## SERVICE BULLETIN

**APPLICABILITY:** 2001MY and later Impreza WRX  
**SUBJECT:** Modification to Rear Brake Caliper

**NUMBER:** 06-36-06  
**DATE:** 06/23/06

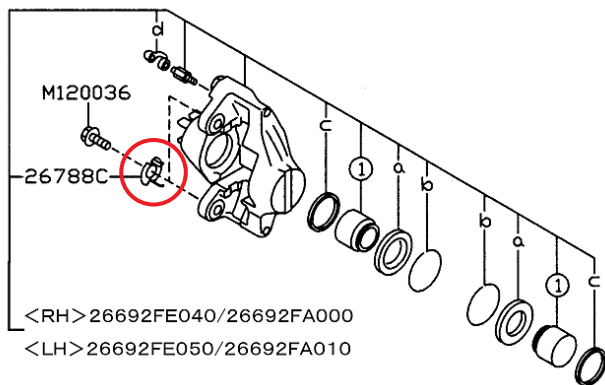
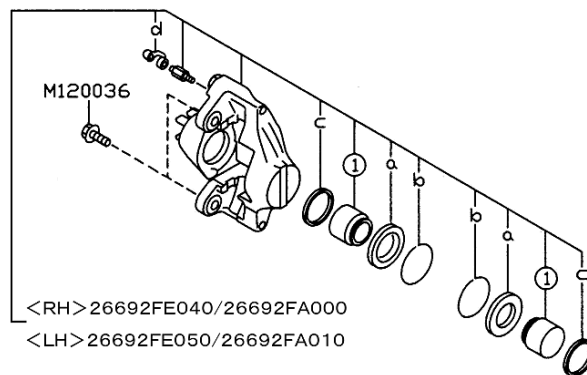
A production change was made to the rear brake caliper on 01MY and newer Impreza WRX. The washer between the caliper body and the backing plate has been discontinued. A change has been made to the caliper body to maintain the correct geometry, although the part numbers have not changed.

Old Disk Brake Kit: 26692FE040/050 (LH/RH)

New Disk Brake Kit: 26692FE040/050 (LH/RH)

**Note:** Though there were design changes made to this part, the part numbers remain the same.
